FED. ROAD DIST. NO.	STATE	PROJ. NO.	FISCAL YEAR	SHEET NO.	TOTAL SHEETS
HAWAII	HAW.	83F-01-99	2006	C.O.ADD.22	28

STATE OF HAWAII DEPARTMENT OF TRANSPORTATION HIGHWAYS DIVISION
FIRE HYDRANT RELOCATION
KAMEHAMEHA HIGHWAY Intersection Improvements At Kahekili Highway Project No. 83F-01-99
Date: November, 2005

C.O.ADD.22

FIRE HYDRANT CONNECTION PLAN
STA. 240+02± o/s 0.5±, Rt.
Not to Scale

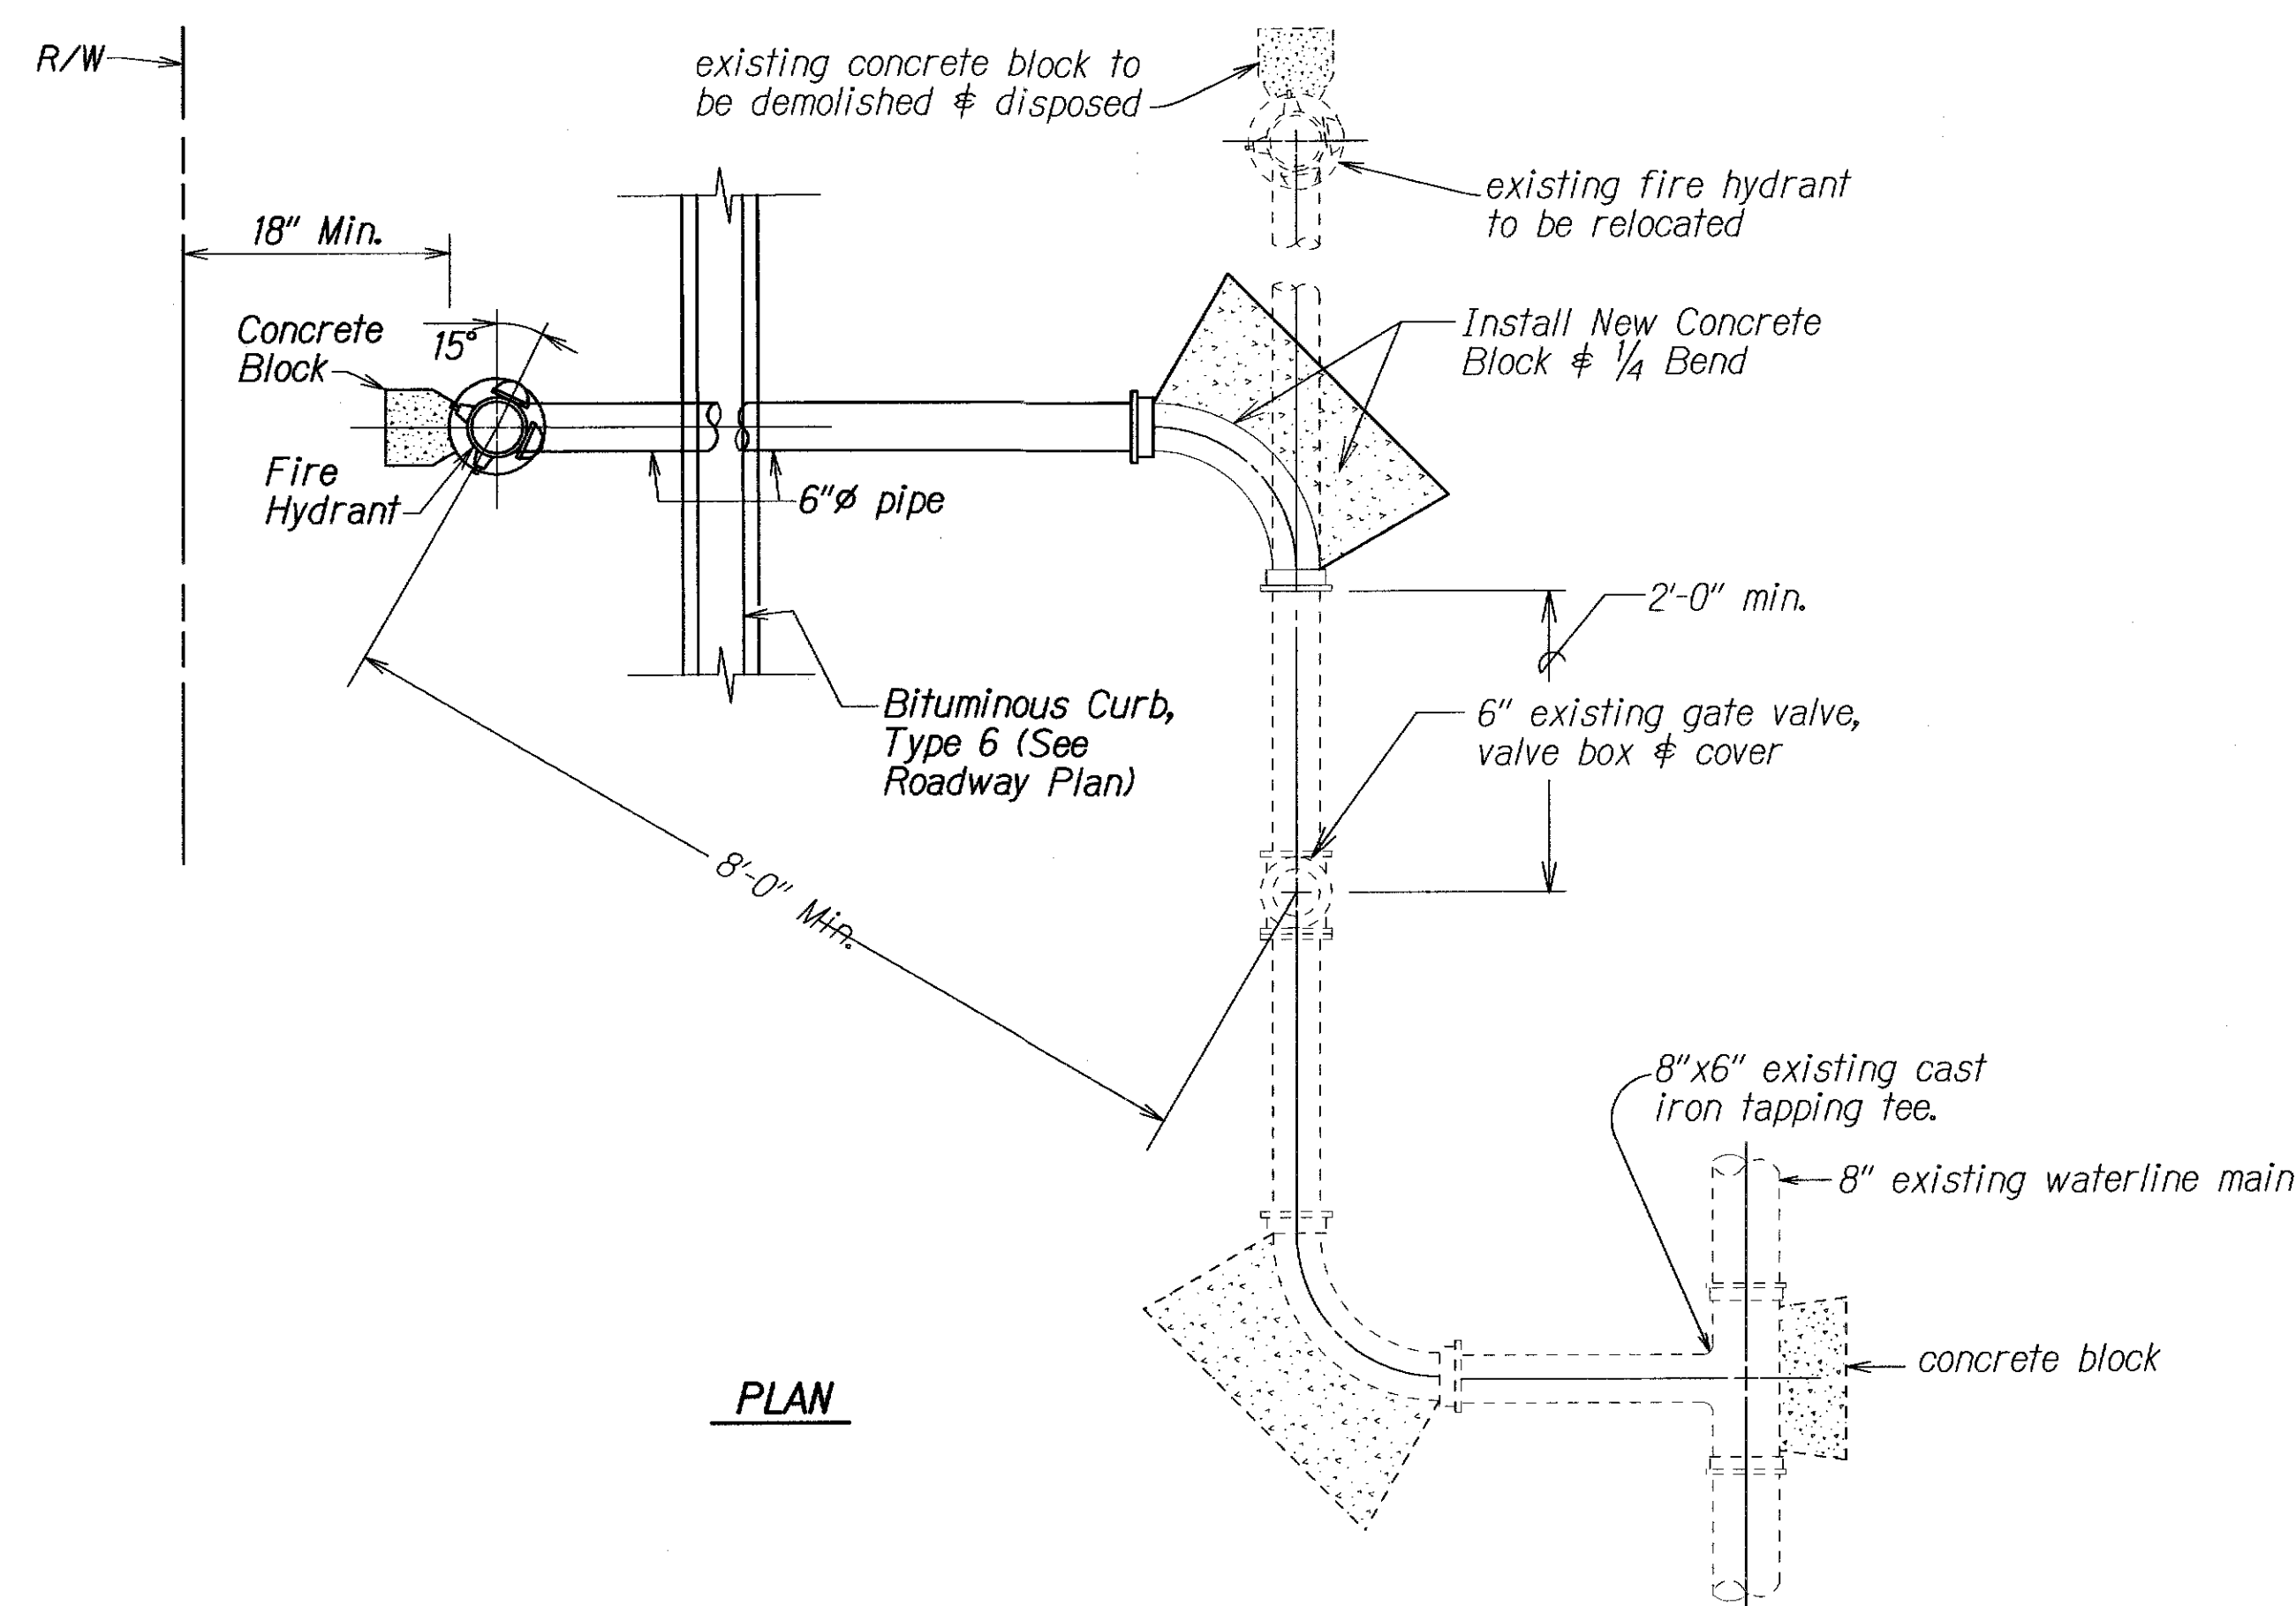
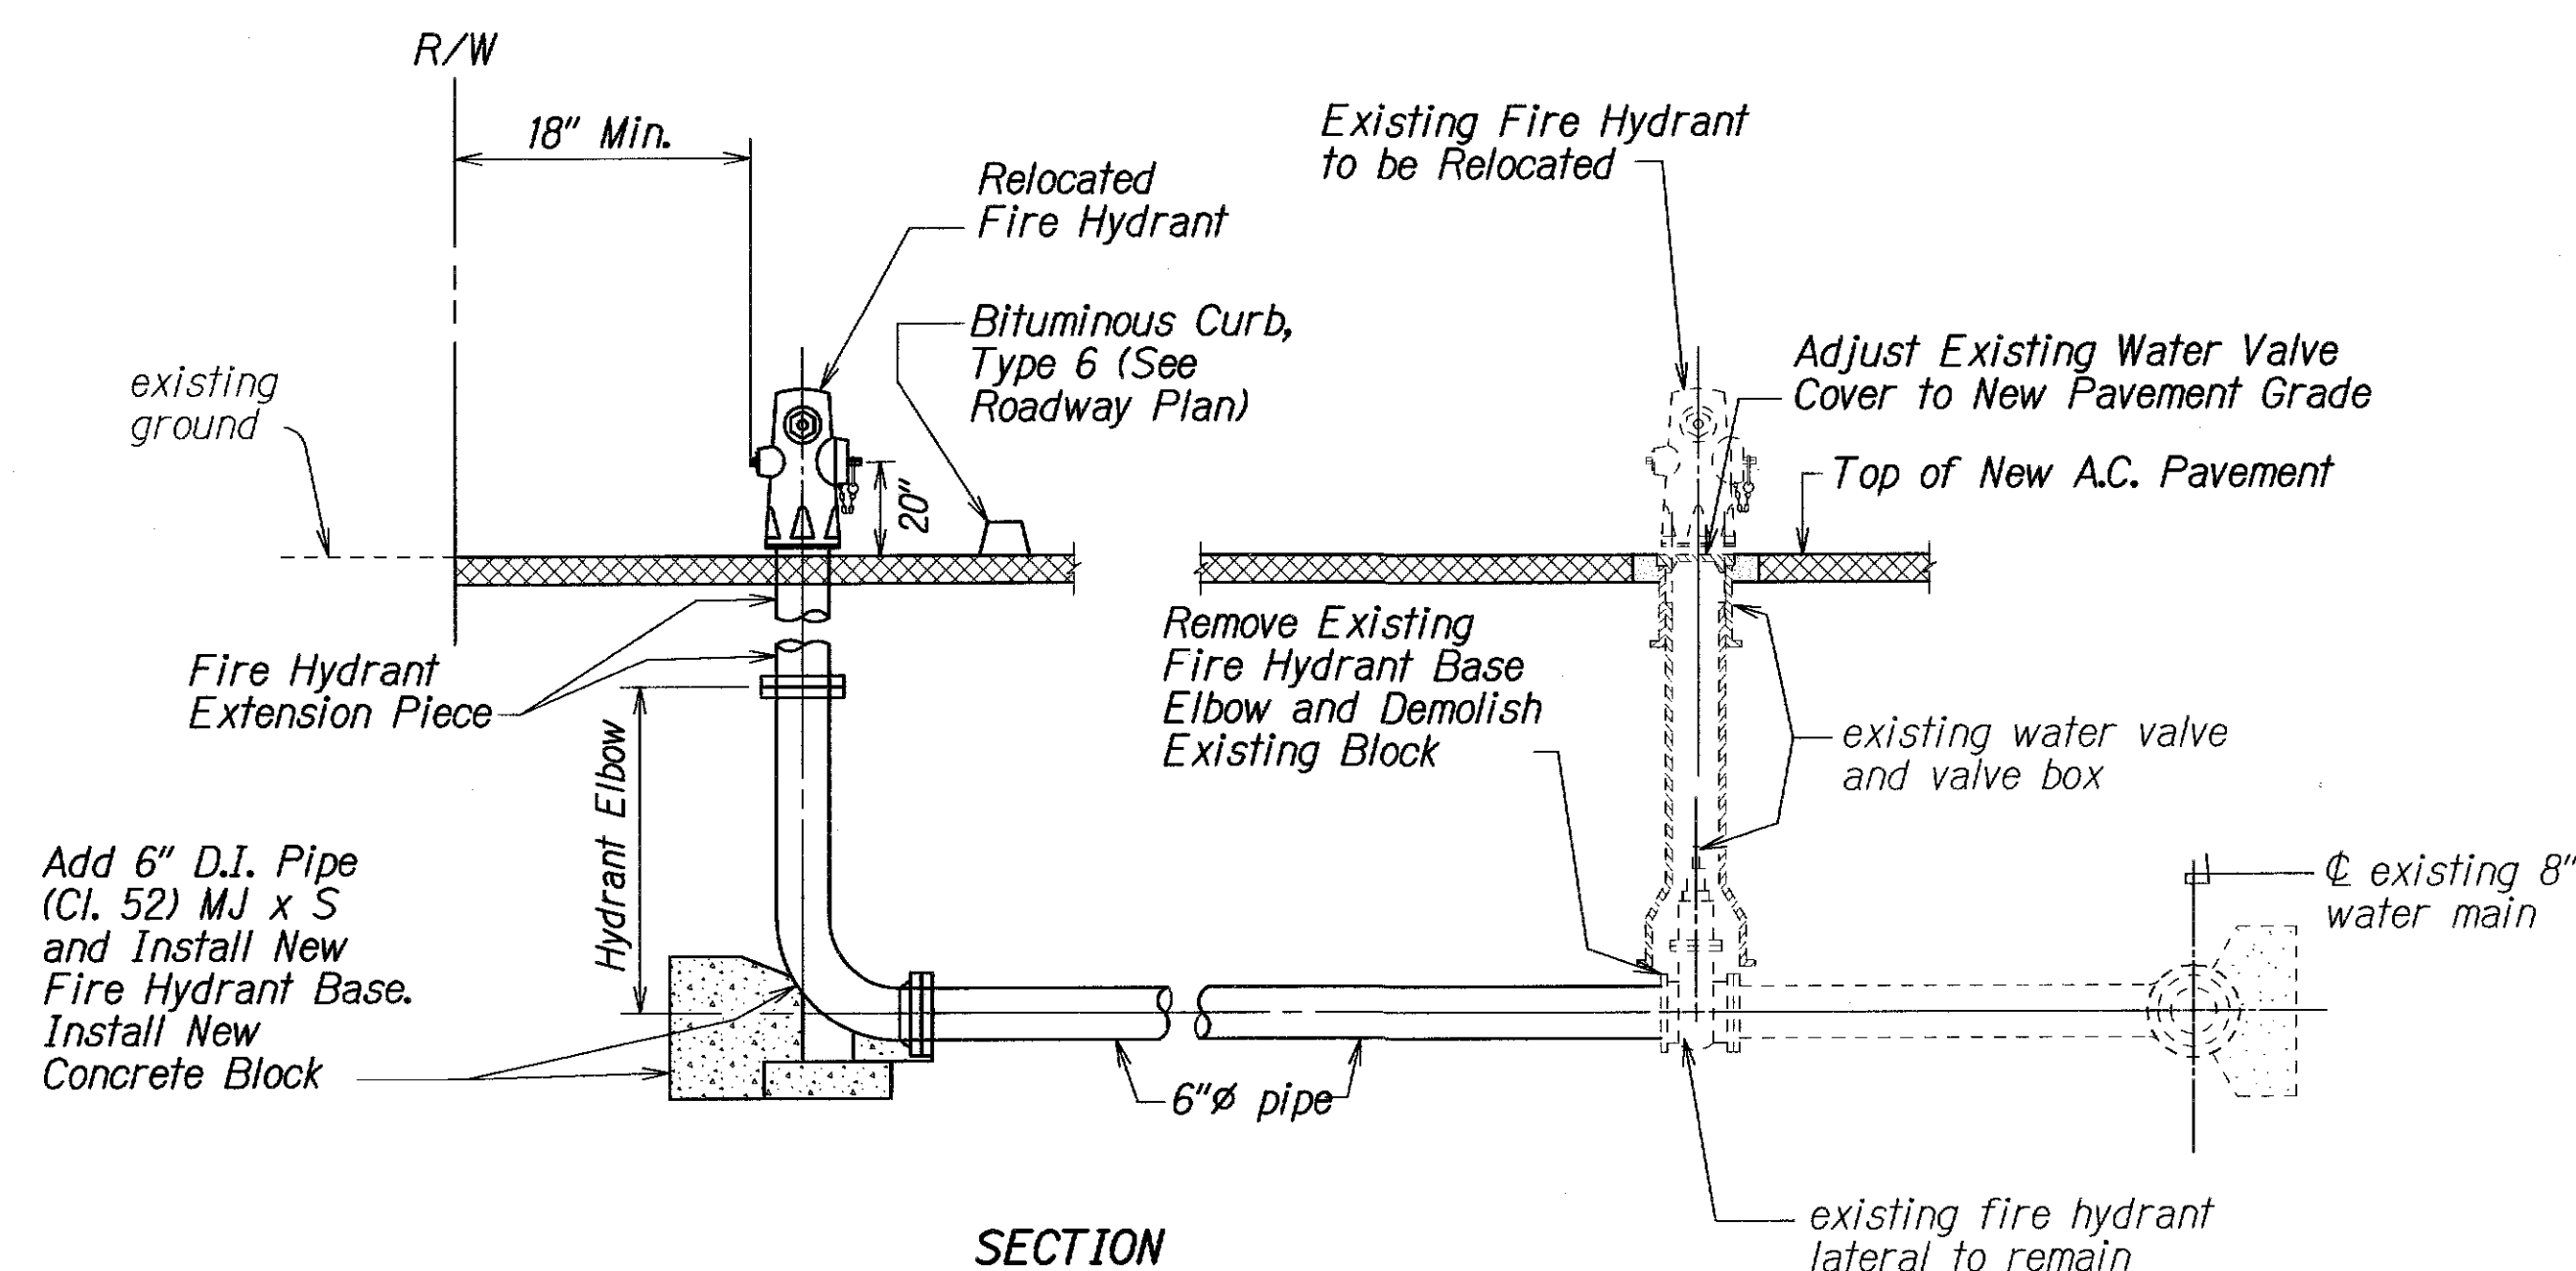
7/17/09	Relocate Fire Hdrant and Waterline.
6/19/06	Revise Plan to show Existing Fire Hydrant and Added BWS Approval Signature.

- # Sta. 240+02±, Rt.
Relocate Existing Fire Hydrant
1 - Relocate FH (#W724)
2 - 6" 1/4 Bend
1 - Valve Box with Concrete Slab
2 - Concrete Block
1 - Fire Hydrant Extension Piece
1 - Fire Hydrant Marker
1 - 6" Sleeve, 12" Long
8± L.F. 6" D.I. Pipe, Cl. 52
Temp. For Testing
1 - 6" Cap with 2 1/2" Clean Out
1 - Concrete Block
